Instruction Manual

AEM Infinity V96.5 Update Notes

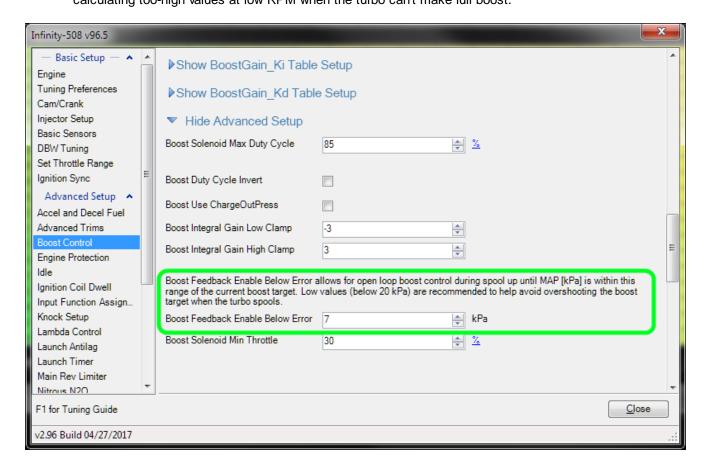
Faster MAP and Fuel Pressure sensor processing rate, to reduce aliasing issues.
 It is recommend to use higher numbers for MAP smoothing filter and Fuel Pressure smoothing filter, beta testers have found good results with 90-95%. This allows for a smooth signal without sacrificing response time.

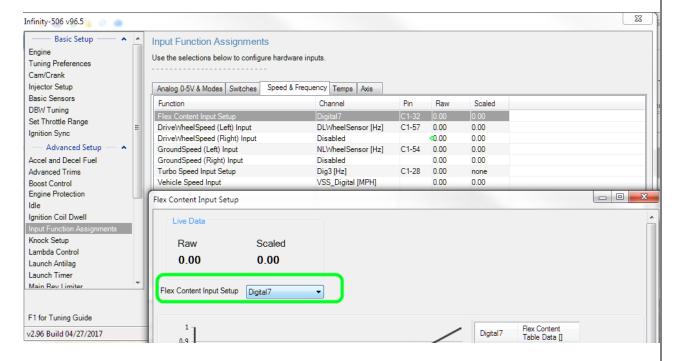
New option 'Boost Feedback Enable Below Error'
 Setting this to small numbers (5-10 kPag) can help avoid overshoot when the turbo first spools up. The default setting (900 kPag) will behave the same as the previous builds, but this often resulted in the PID feedback calculating too-high values at low RPM when the turbo can't make full boost.

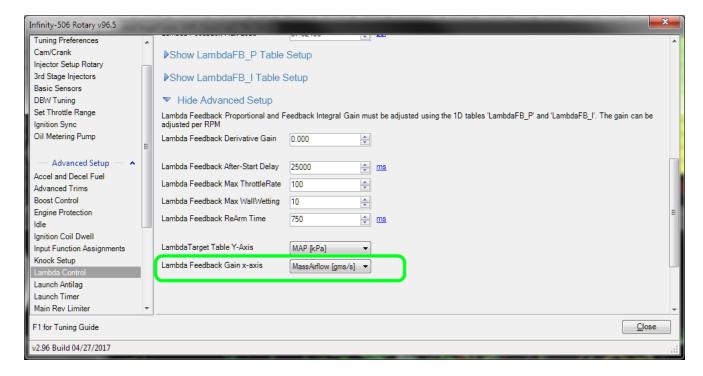
FlexSensorCal table input can be assigned to use Digital on/off switch pins.
 This can be used for adding a simple 'Gas/Ethanol' switch if the user does not want to plumb an actual sensor into the fuel system.

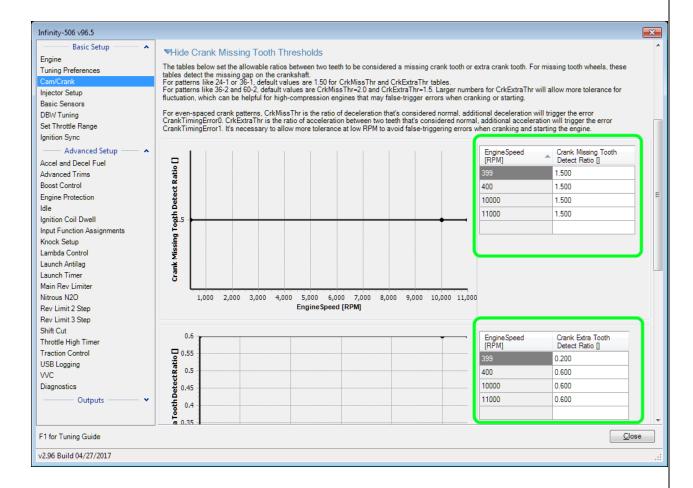
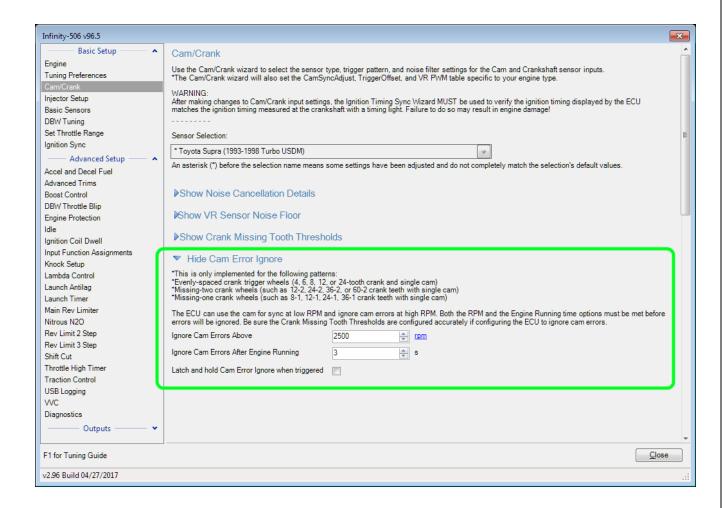
5. Channels 'CrkMissThr' and 'CrkExtraThr' allow the user to define the allowable acceleration ratio between crank edges for the even-spaced cam/crank patterns (such as 12-tooth crank and single-pulse cam). If the crank speed accelerates or decelerates too fast, this will trigger the error CrankTimingError0 or CrankTimingError1. These tables were already present and used for missing-tooth gap detection on some patterns like 36-2, and the firmware has been expanded in this version to include signal error detection for even-spaced crank patterns. Note these table values will be auto-populated based on crank pattern when you import from a previous version calibration, and the calibration will be changed to resync when CrankTimingErrors occur (even if the previous calibration was set to ignore). If you experience no-start or start-then-stall conditions, please save & email datalogs so we can help adjust these table settings to work well with your engine.

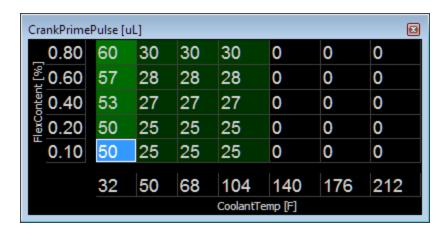
- 6 = Cam0_SyncError2 (missing cam edge or disconnected cam signal)
- 9. New table 'CrankPrimePulse [uL]'
 - Units: Injection volume vs Coolant Temp and FlexContent

Description: This pulse is calculated based on a desired initial pulse volume (in microLiters), which will be injected on all injectors when the ECU detects the first crank signal edge. This can allow some fuel to be injected before the ECU syncs and begins firing the ignition coils. Note there is also some logic to prevent a second priming pulse in the event that the engine does not start on the first attempt or stalls after it has been running. Another prime pulse will only be allowed after the ECU has been powered off. This feature is available for the following timing patterns only: Any even spaced crank tooth pattern with single cam pulse any crank missing-1 and crank missing-2 patterns with a single cam.

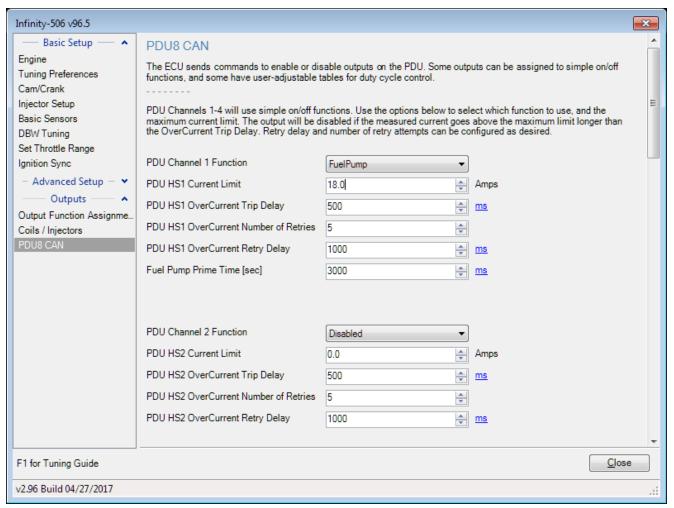
PDU Channels 1-4 are simple on/off functions, with a dropdown selection in the wizard page. Use the wizard to set the Overcurrent and retry settings.

In the screenshot above, The HS1 output will turn off if the measured current is above 18.0 amps for 500ms (0.50 seconds). The output will stay off for 1000ms (1.0 second) and then retry. The output will only retry 5 times, after the fifth overcurrent event it will stay off until the ECU turns off and restarts.

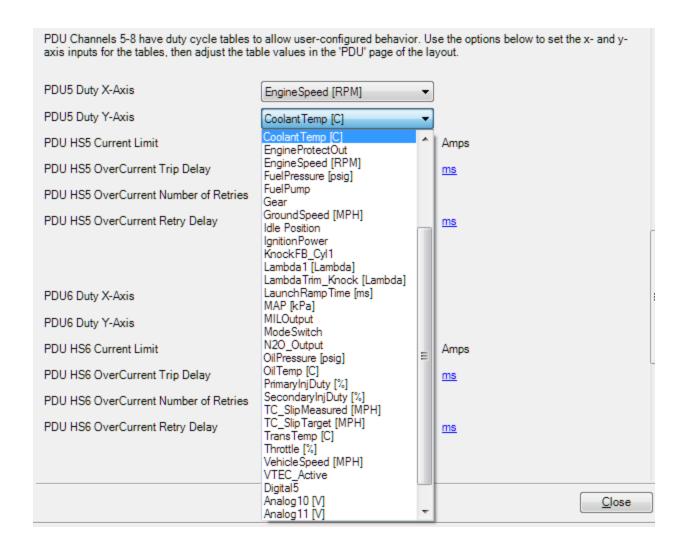
PDU Channels 5-8 include duty cycle tables. Users can select the table axis in the wizard, but must configure the table values manually in the layout. Note that some raw Digital and Analog inputs can be selected for the table axis. Note the output frequency is fixed at 100 Hz.

The layout page also displays measured current, maximum allowed current, and the raw status flag (0, 1, 2, or 3) for all channels.
